HILLIARD PLANNING AND ZONING BOARD MEETING

SUBJECT: Planning and Zoning Board approval of Site Plan Application No. 20240131. Parcel #16-3N-24-0000-0024-0070. Applicant: Karen Brantley, Florida Infrastructure.

Site Plan Application 20240131 Florida Infs.
Review Report

RE: Determination of Completeness and Site Plan Review
Florida Infrastructure Truck Shop
Town of Hilliard, Florida
Mittauer & Associates, Inc. Project No. 9610-23-26

WET POND CROSS SECTION

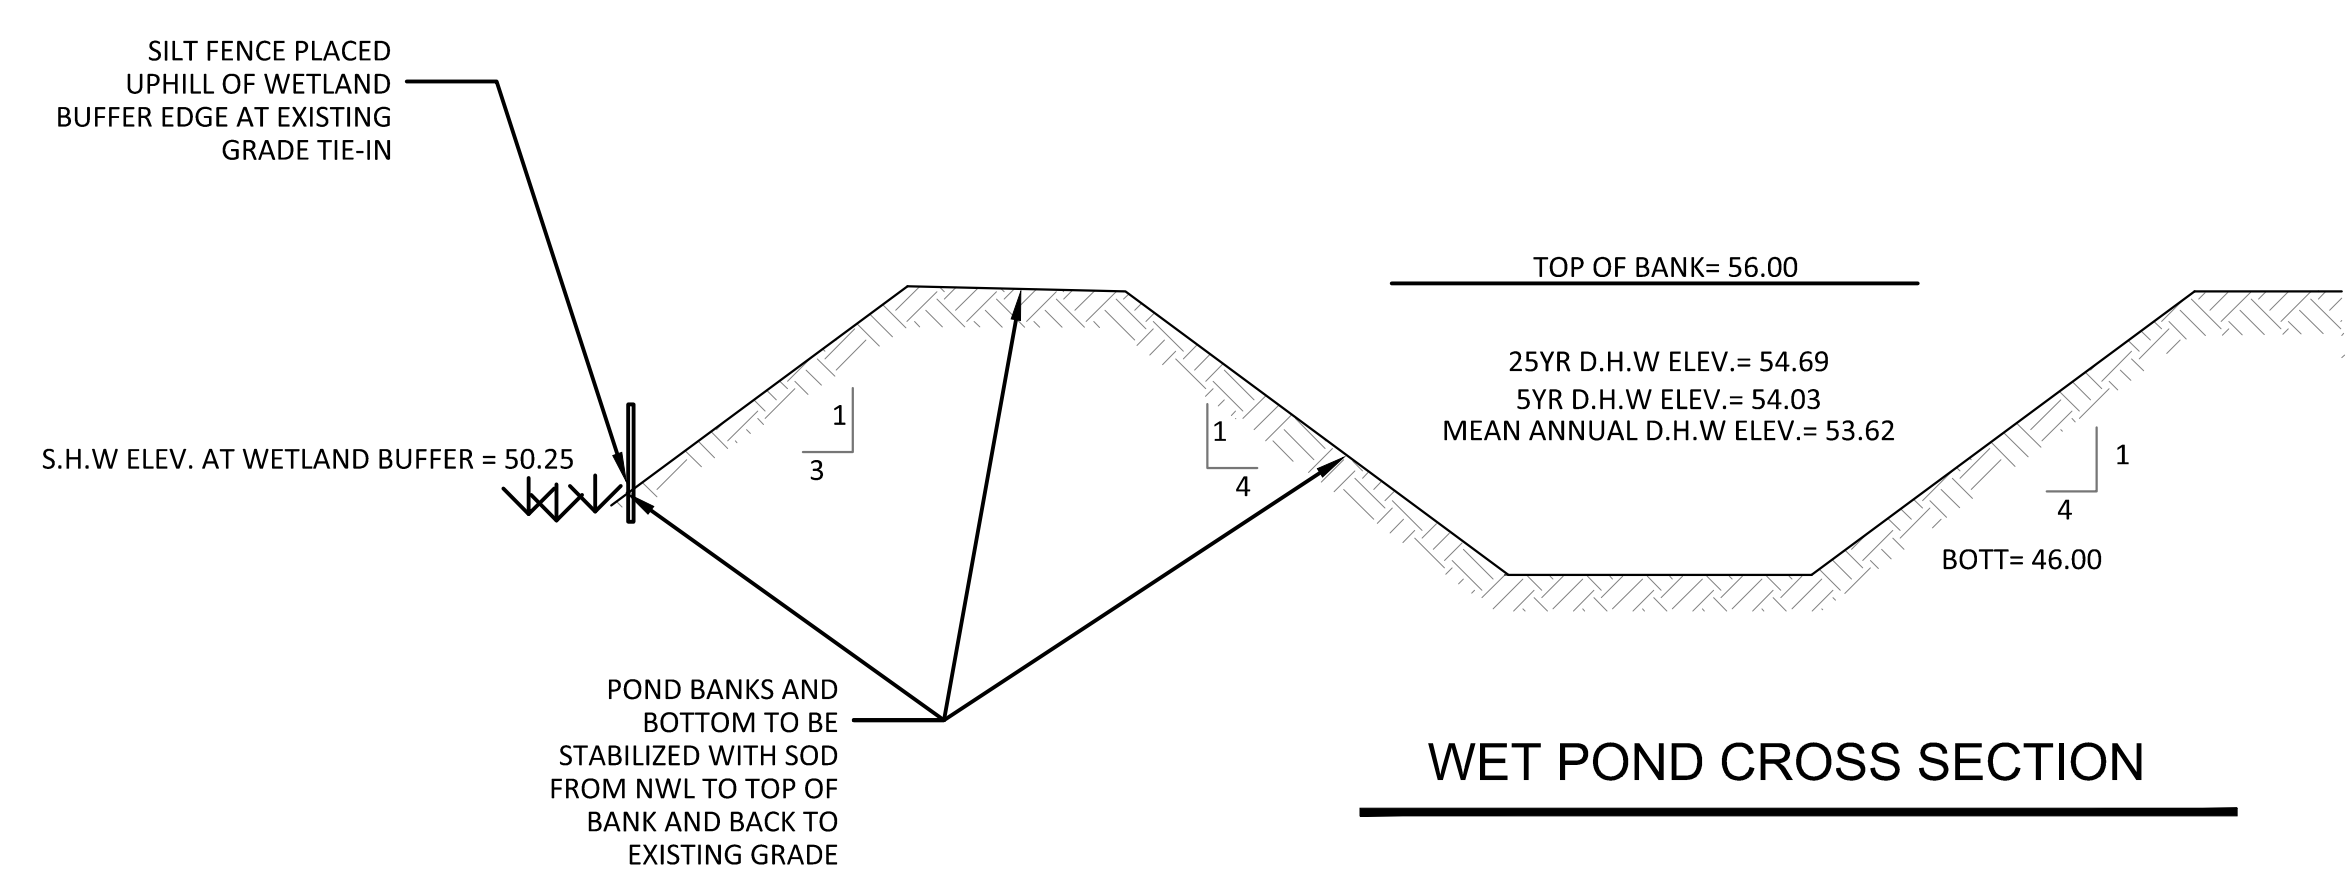
1. Verify the Bottom Elevation of the Wet Pond. Cross Section shows 41.50, while other Sheets appear to show 40.0. Update throughout, as needed.
2. Recommend Asphaltic Concrete Driveway section match the Std Duty Pavement section above for consistency.

1. Verify the Bottom Elevation of the Wet Pond. Cross Section shows 41.50, while other Sheets appear to show 40.0. Update throughout, as needed.
Pond cross section has been revised.
